<b>SOLARRESERVE KOTULO TSATSI ENERGY CONCENTRATED SOLAR (CSP) 1 FACILITY, NEAR KENHARDT, NORTHERN CAPE PROVINCE</b>		
<b>COMMENTS RECEIVED ON THE FINAL EIA REPORT FOLLOWING 21 DAY REVIEW PERIOD AND SUBMISSION TO DEA AND LATE COMMENTS</b>		
<b>NO.</b>	<b>COMMENT/ISSUE RECEIVED</b>	<b>RESPONSE TO ISSUES RAISED</b>
<b>1. ACKNOWLEDGMENT RECEIVED FROM NC DENC DATED 03 MAY 2016</b>

Figure 1: Solar Farm components

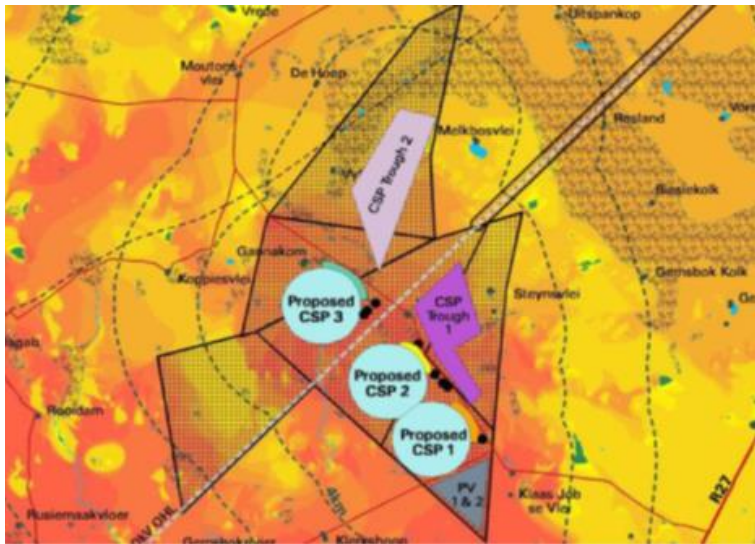
b. Figure 1 basically shows how the entire development engulfs the relevant farm portions even if the footprint hectares indicated by the EAP seems small. The only farm portion not developed is one on the western side. The areas in between the development components are calculated as non-development, but due to the integrated nature of figure 1 the impacts will be much wider than the said 6000 ha. We are of the opinion that at least 20 000 ha will be affected inside the "Solar Reserve". The EIA did not consider the interconnectivity of development components during operations.

The statement that PHS Consulting is of the opinion that "at least 20 000 ha will be affected" is factually incorrect.

1. The entire area shown in the Figure 1 is 20 700 ha in extent. Therefore 20 000 ha cannot reasonably be affected by the proposed projects.
2. Each CSP facility, together with its associated infrastructure, has a development footprint of 1000 ha.
3. Therefore, the CSP3 facility (authorised), plus the CSP1 facility (subject of this EIA) and the CSP2 facility (separate application for authorisation) impact on a cumulative area of 3000 ha. This is less than 15% of the 20 700 ha area shown in the Figure 1.
4. The two CSP trough plant applications as shown in the Figure 1 have since lapsed.

Chapter 8 of the FEIR addresses and considers cumulative impacts (i.e. interconnectivity of the CSP development components) during operations, and as such this comment is factually incorrect.

Figure 2: Source - SEA www.csir.co.za & DEA

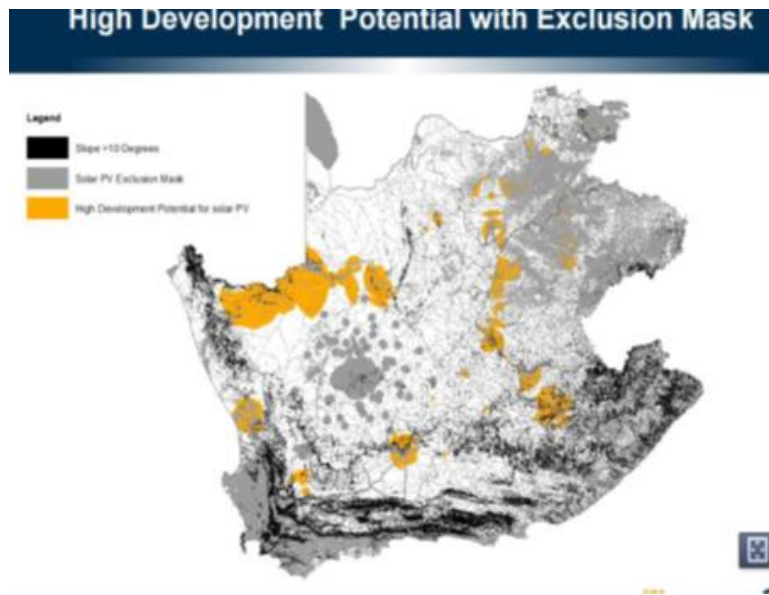
F	<p>Wrt the Strategic Environmental Assessment for Wind and Solar Photovoltaic Energy in South Africa (CSIR, 2015) the EAP shows disregard for good quality research and guidelines. The EAP try and make out a case that CSP is completely different than PV, therefore not covered by the various strategic studies. The bottom line is that CSP is regarded as renewable solar energy that require the same resources and infrastructure than Wind and PV, therefore the CSIR documentation need to be recognised.</p>	<p>Through their participation as part of the REDZ SEA Expert Reference Group, the EAP is fully knowledgeable of the REDZ and the rationale behind the identification of the Focus Areas. As such, the EAP is also fully knowledgeable of the DEA’s direct decision to only include wind and solar photovoltaic technologies in the determination of focus areas.</p> <p>Solar PV and CSP technology are completely different technologies and function completely differently.</p> <p>Sections 4.1.7 and 4.2 of the FEIR provide a detailed description of CSP technology. The identification of Focus Areas resulting from the Strategic Environmental Assessment for Wind and Solar Photovoltaic Energy in South Africa (CSIR, 2015) was done only after the site was identified by</p>

<p>the Applicant and after the application for authorisation for the CSP1 Project was lodged. The SEA does not include CSP technology nor is the SEA mandated in NEMA to be used as a baseline for any infrastructure projects in South Africa.</p>
<p>G</p>	<p>The SEA process considered both negative and positive mapping to identify RE development areas. Positive key factors including transmission loss, local municipalities with high social need and high potential for development, priority areas for renewable energy manufacturing and import activities, and existing transmission infrastructure were considered. This also applies to CSP's. Negative mapping entail environmental and technical constraints to eliminate areas with highly sensitive features consisting of environmental features (e.g. protected areas and areas of known bird and bat sensitivity), existing and future planned land uses (e.g. agriculture), existing infrastructure (e.g. electricity grid), existing national plans (e.g. Square Kilometre Array electro-magnetic telescope project). This also applies to CSP's.</p> <p>The idea was to identify large clusters of land with the lowest environmental sensitivity, overlaid with the highest development potential areas per province. The priority development areas were then identified. Specialist scoping level pre-assessments were then undertaken in the REDZ for agriculture, landscape, heritage, terrestrial and aquatic biodiversity, birds, bats, and socio-economic sensitivities.</p> <p>Below is a map (figure 2) extracted from the CSRI &amp; DEA SEA, the red star is the approximate location of the approved CSP 3. It is clearly outside of high development potential areas and within an exclusion area. The grey exclusions in this case relate to SKA reserve area, sensitive wetland drainage patterns and ecological corridors.</p>	<p>The extracted map is for high development potential areas for PV and wind only. This does <u>not</u> apply to CSP technology, nor has this been gazetted to be used as a baseline for renewable energy infrastructure development in terms of the NEMA or any other infrastructure development legislation.</p> <p>PHS Consulting's inference that this applies to CSP is fundamentally flawed, however, the following should be noted:</p> <ul style="list-style-type: none"> <li>- Only the dark grey areas are flagged as exclusion areas, and relate to SKA satellite stations. There is no direct overlap with the Kotulo Tsatsi site and the exclusion areas shown, or SKA sites.</li> </ul> <p>In terms of the documentation released by the CSIR, 2015, the following should be noted regarding the DEA's position is concerning the REDZ, and that the need for detailed assessment at a project level, even within a Focus Area, would be required. The following is a direct quote:</p> <p>CSIR, 2015:          "Scoping level pre-assessments of the biophysical and social environments have been undertaken as part of the SEA to produce sensitivity maps for the proposed REDZs. The sensitivity maps are based on the best available data, but are not sufficiently detailed to support project level decision making in terms of the National Environmental Management Act (NEMA) (Act 107 of 1998). The maps instead identify potential sensitivities to inform environmental assessment at a project level. Environmental Authorisation in terms of NEMA will be based on the outcomes of a project level environmental assessment and not the outputs of this SEA study."</p> <p>The REDZ nodes are not gazetted and areas falling outside of REDZ are not intended to be excluded from development of renewable energy projects.</p>

The purpose of the REDZ is to streamline applications falling within them. The study area of the proposed project has thus not been ruled out for development. In addition, it must again be noted that the REDZ proposed to be gazetted are for Solar PV and Wind technology projects only.

A large area (20 700 ha) was subjected to scoping level assessments (for agriculture, landscape, heritage, terrestrial and aquatic biodiversity, birds, ecology, and socio-economic sensitivities) which identified no-go areas and lead to the proposed 1000 ha being chosen.
